**TOWN OF BROOKLYN
PLANNING AND ZONING COMMISSION
Special Meeting Agenda
Tuesday, August 15, 2023 6:30 p.m.**

ENGINEERING SITE PLAN & DRAINAGE REPORT REVIEW

The comments contained herein pertain to my review of a set of plans, consisting of fifteen (15) sheets (sheet 15 architectural missing), entitled "Special Permit Site Development Plan Prepared for Townsend Development Associates, LLC, Providence Road (Route 6), Brooklyn, Connecticut, Dated: May 5, 2023, Revised: N/A," prepared by CHA and Drainage Report, dated May 24, 2023, by CHA.

EXISTING CONDITIONS

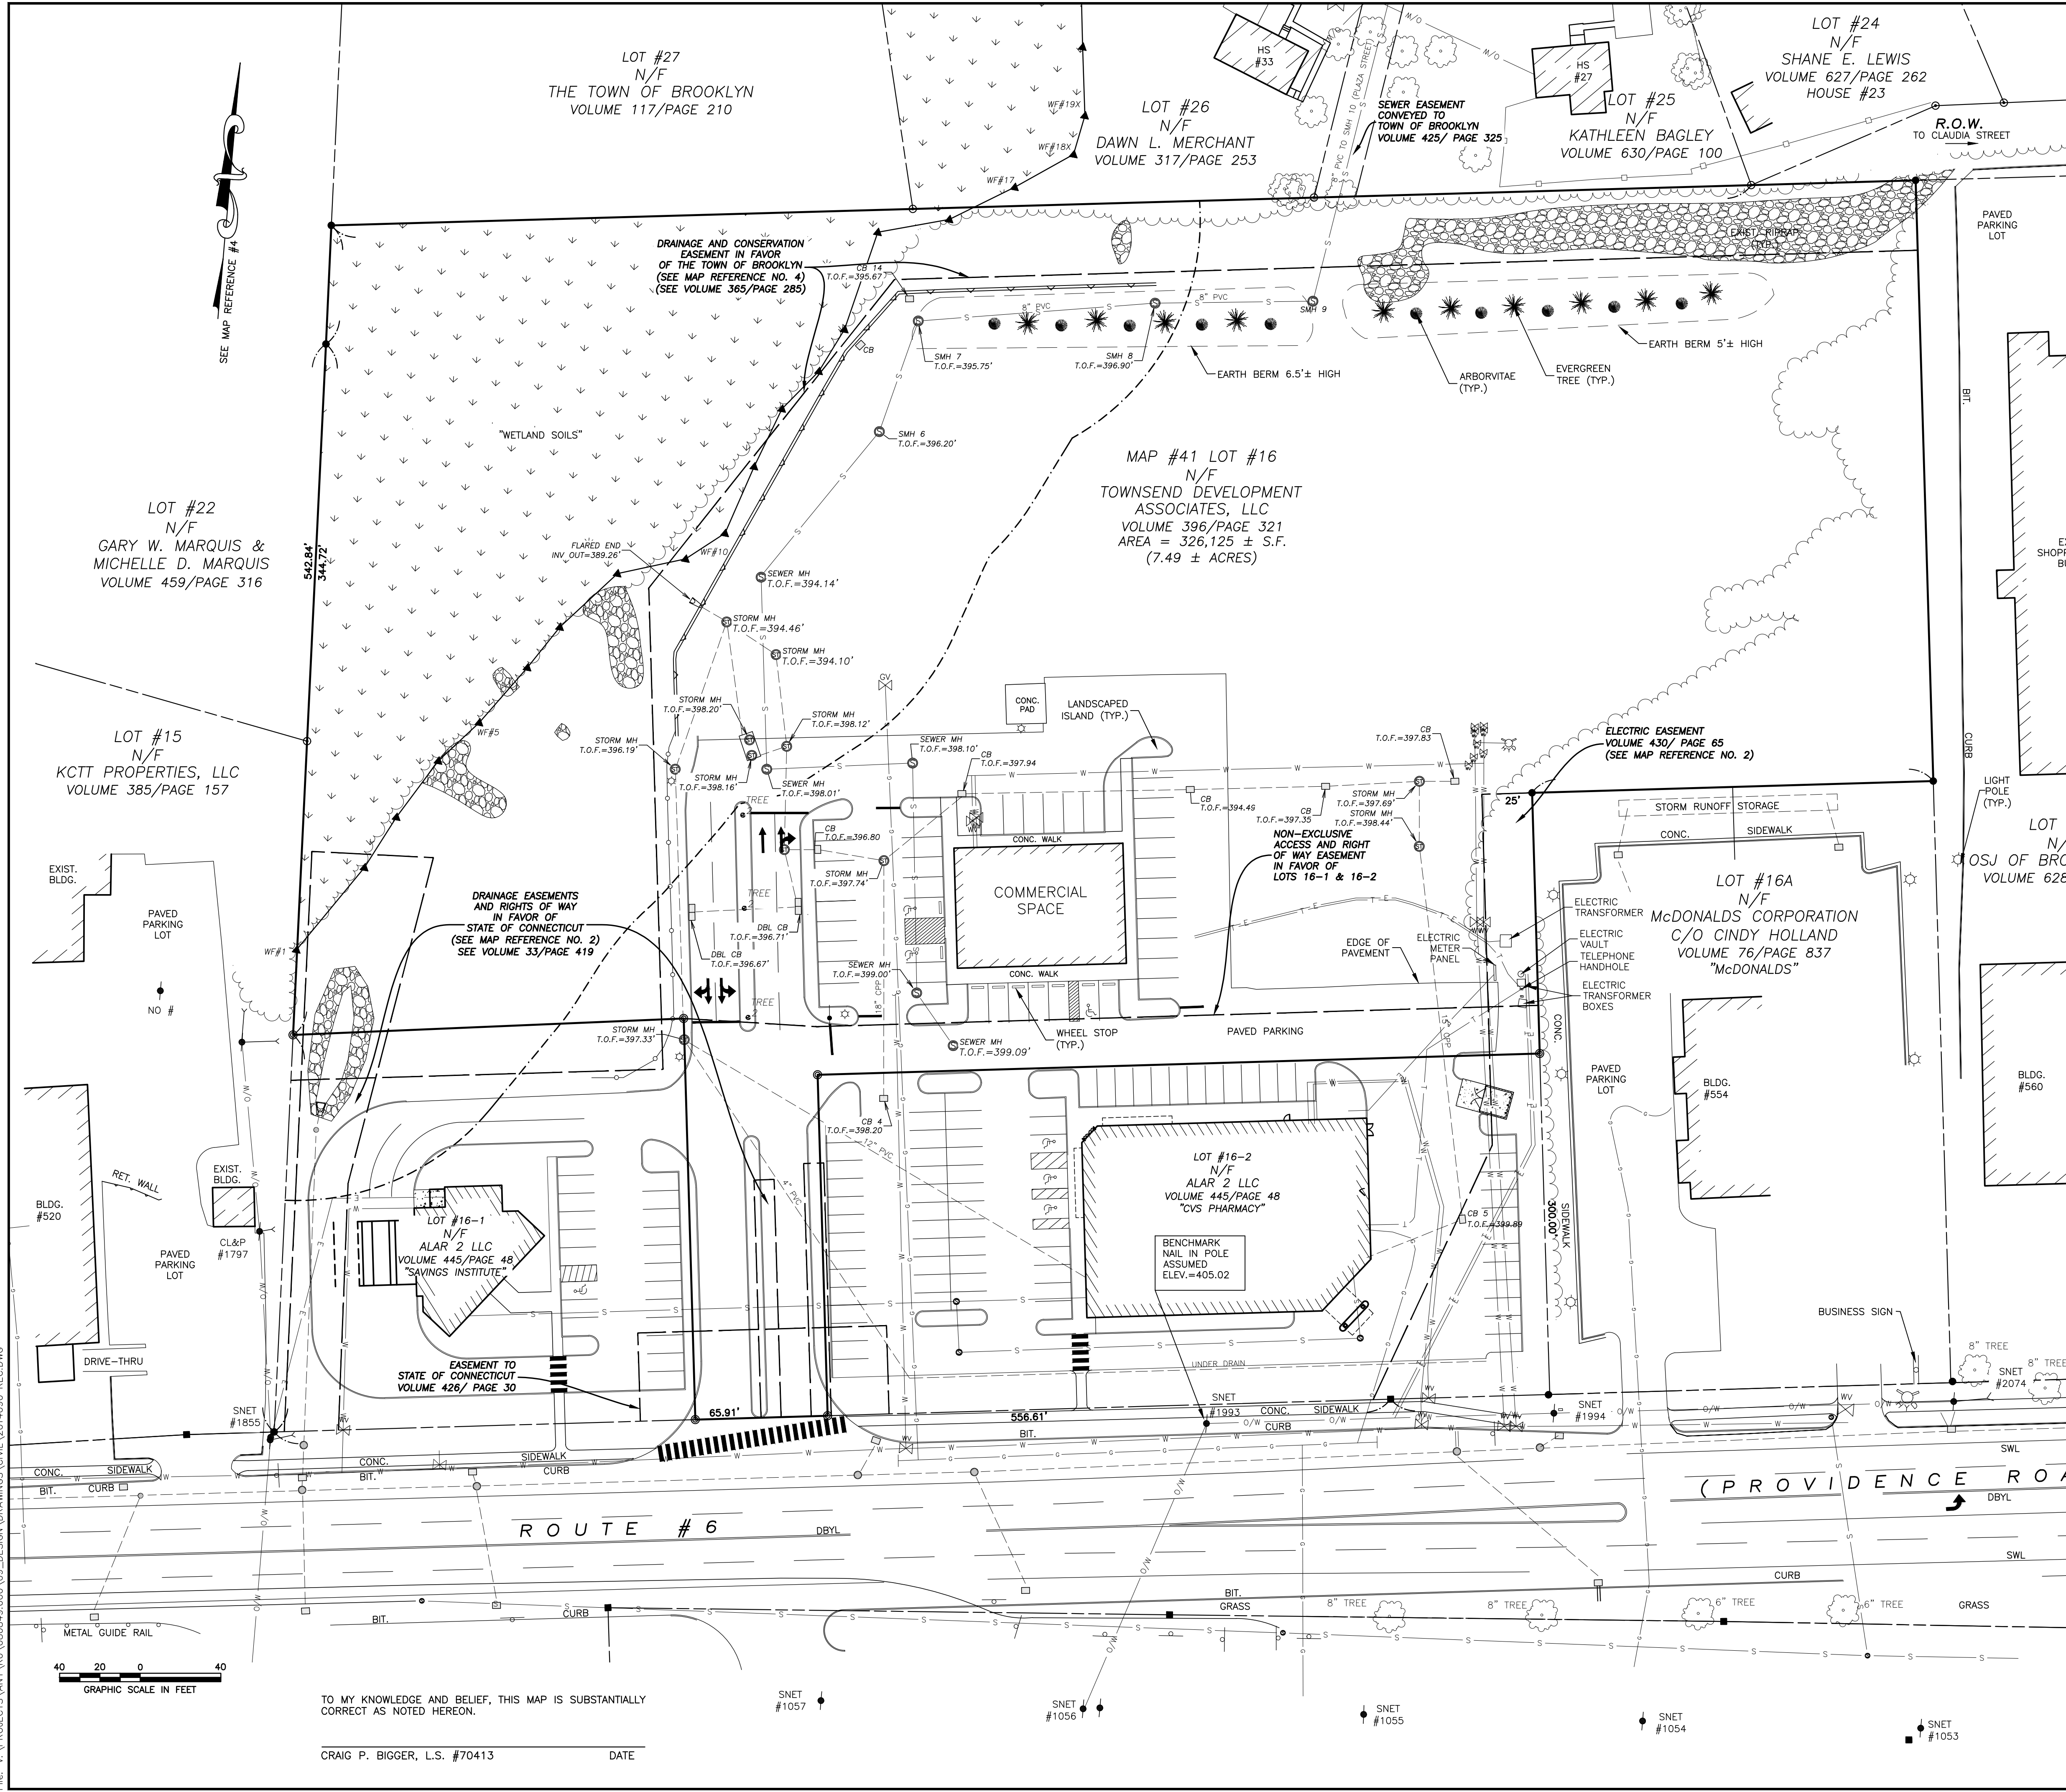
1. Are all of the abutting property owners shown on the 2017 plan present today? If not, a new large scale plan or drawing needs to be included in the plan set with current owners, similar to the "inset site installation drawing" included in Drawing No. 13.

1. Are all of the abutting property owners shown on the 2017 plan present today? If not, a new large scale plan or drawing needs to be included in the plan set with current owners, similar to the "inset site installation drawing" included in Drawing No. 13.
Drawing 2 has been updated to revise the current Owners.

LAYOUT PLAN

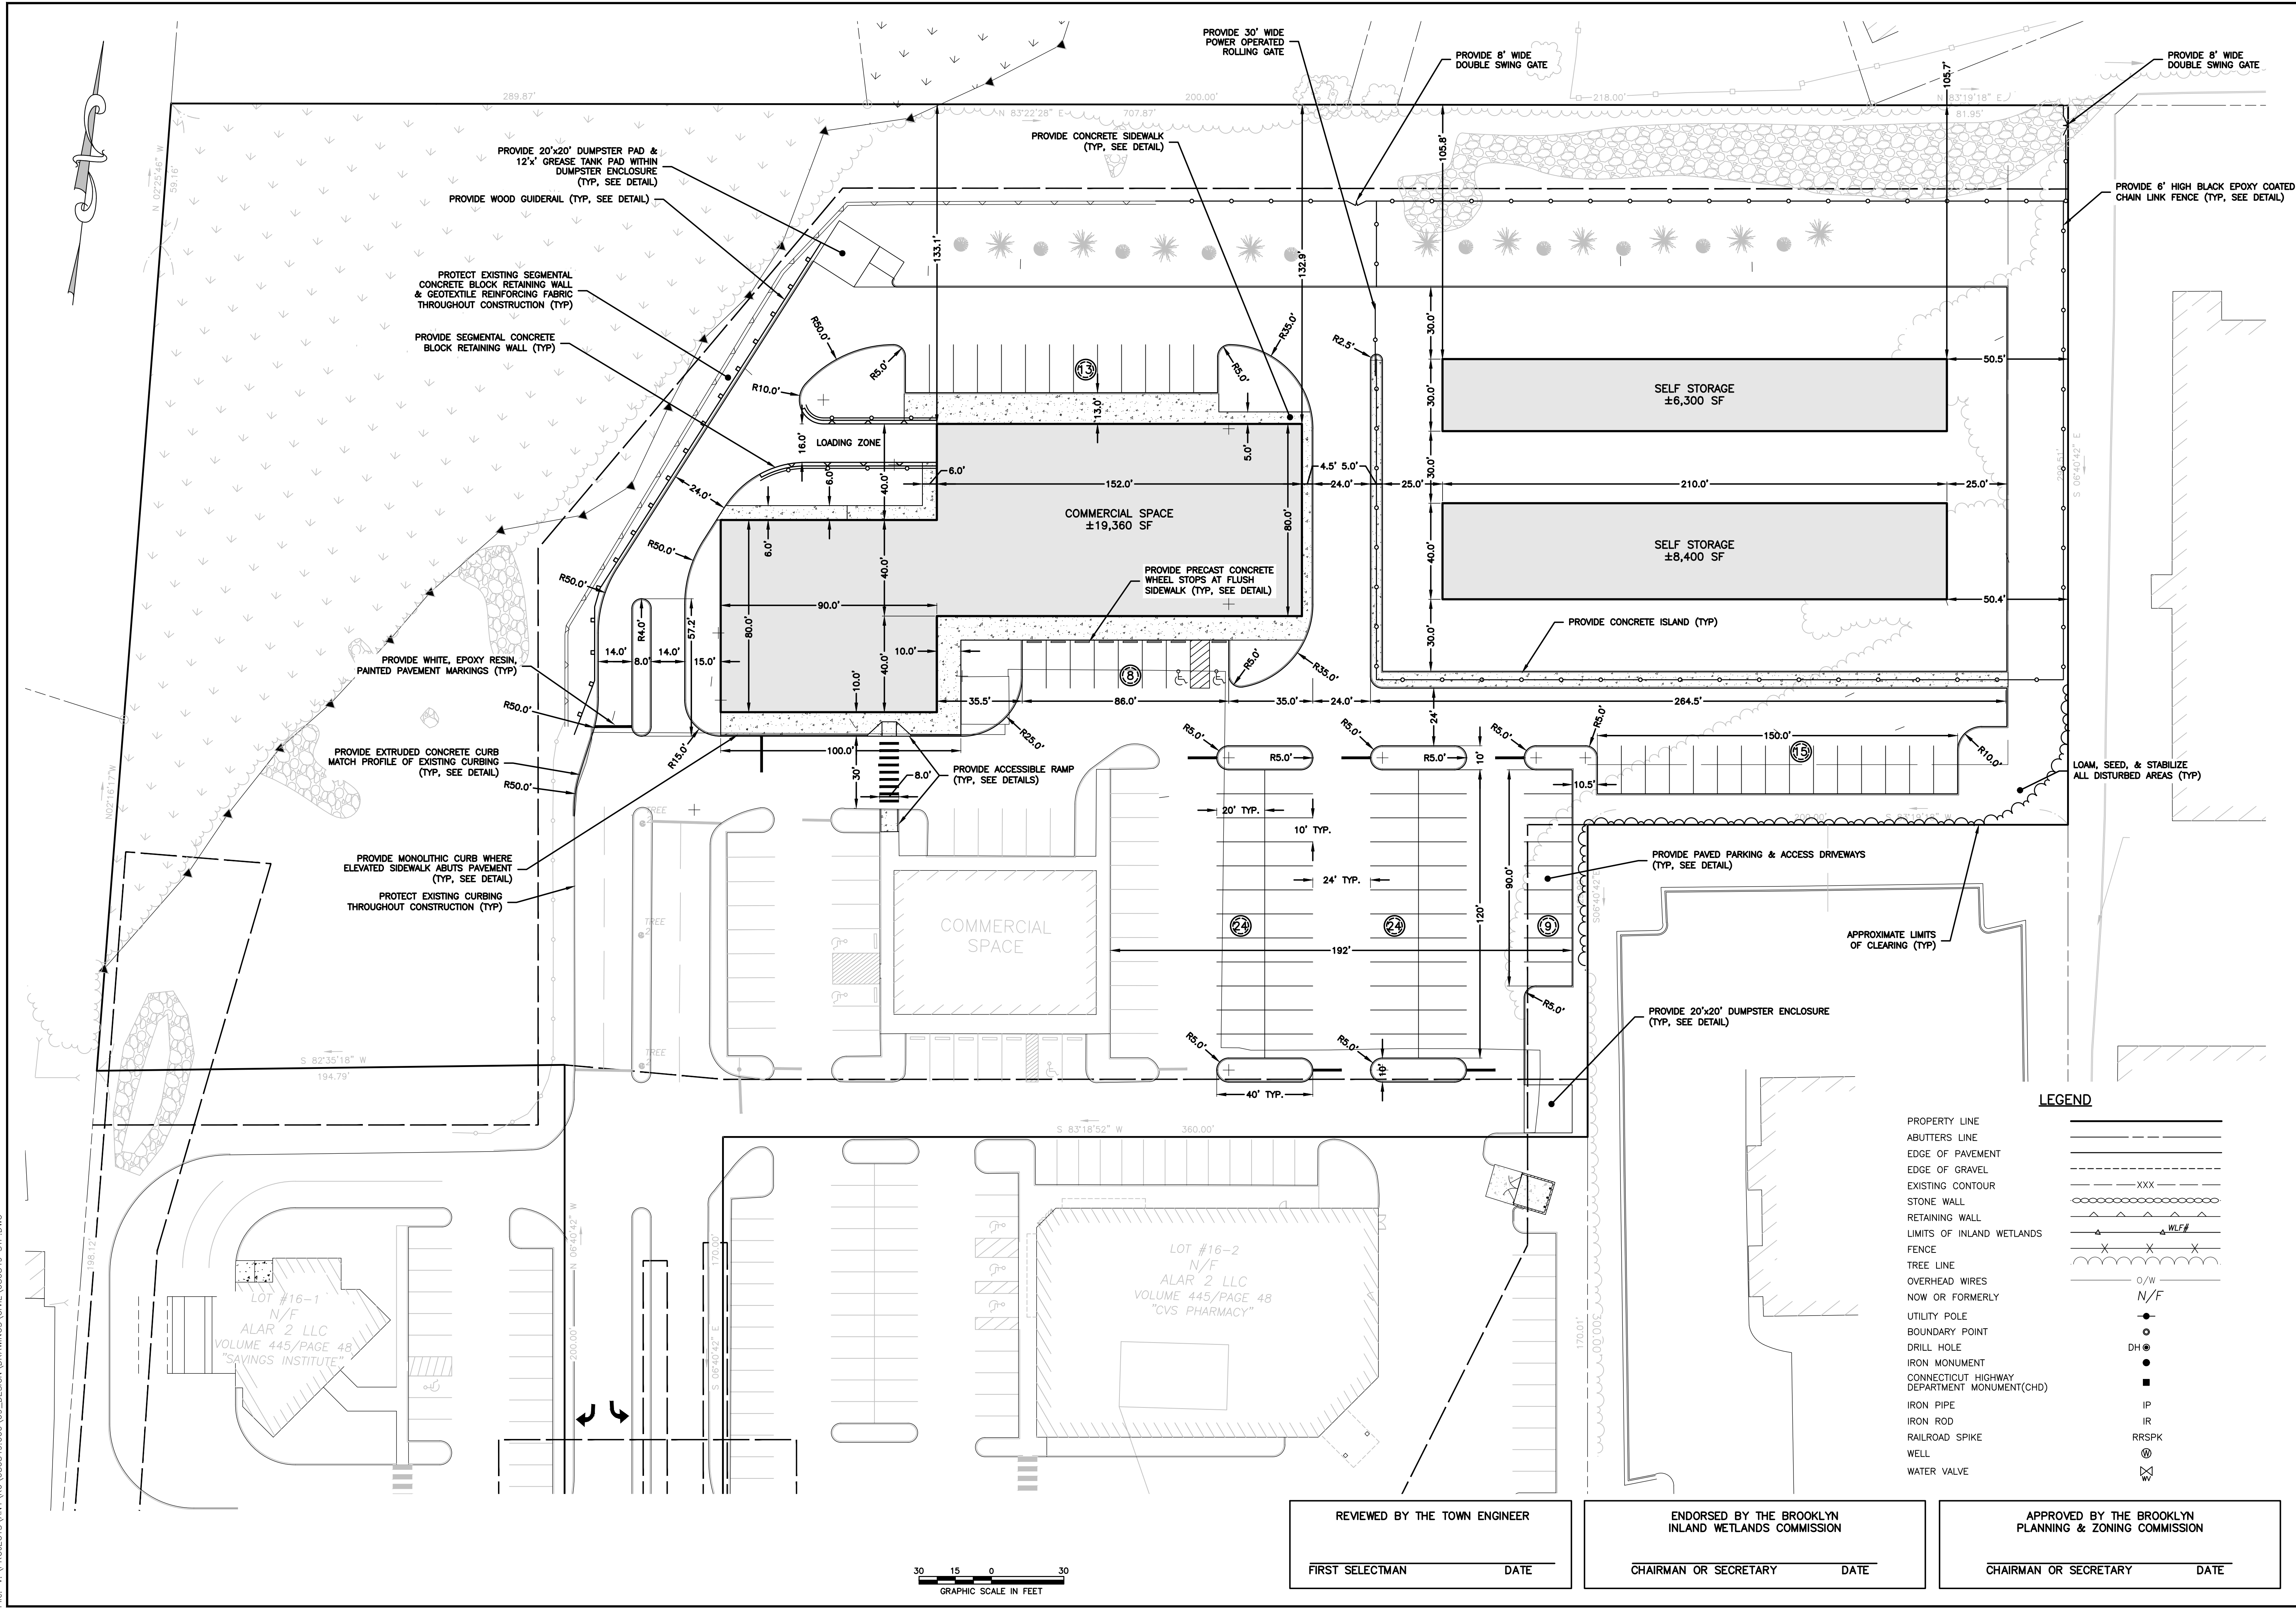
1. Not all sidewalks shown are dimensioned. All sidewalk widths need to be specified on the plan.
2. If the sidewalk at the south end of the proposed crosswalk is not flush with the pavement, a sidewalk ramp will need to be constructed there and a construction detail provided — see Type 17 on CT DOT "Sheet 6 – Sidewalk Ramps."

3. The layout plan is missing some dimensions for curb radii, tangents, aisle widths, loading zone width, etc. All dimensions need to be shown to be able to call this a true layout plan. Scaling dimensions off the plan where no dimensions are shown is unacceptable as this is prone to reading error and distortion in a paper printing process.

4. The "Commercial Space" building footprint is missing dimensions; however, the "Self Storage" units do have dimensions shown. Add all dimensions to the commercial space.

1. Not all sidewalks shown are dimensioned. All sidewalk widths need to be specified on the plan.
Additional dimensions have been added to the plan set.
2. If the sidewalk at the south end of the proposed crosswalk is not flush with the pavement, a sidewalk ramp will need to be constructed there and a construction detail provided — see Type 17 on CT DOT "Sheet 6 – Sidewalk Ramps."
A new sidewalk ramp and detail are now provided.
3. The layout plan is missing some dimensions for curb radii, tangents, aisle widths, loading zone width, etc. All dimensions need to be shown to be able to call this a true layout plan. Scaling dimensions off the plan where no dimensions are shown is unacceptable as this is prone to reading error and distortion in a paper printing process.
Additional dimensions have been added to the plan set.
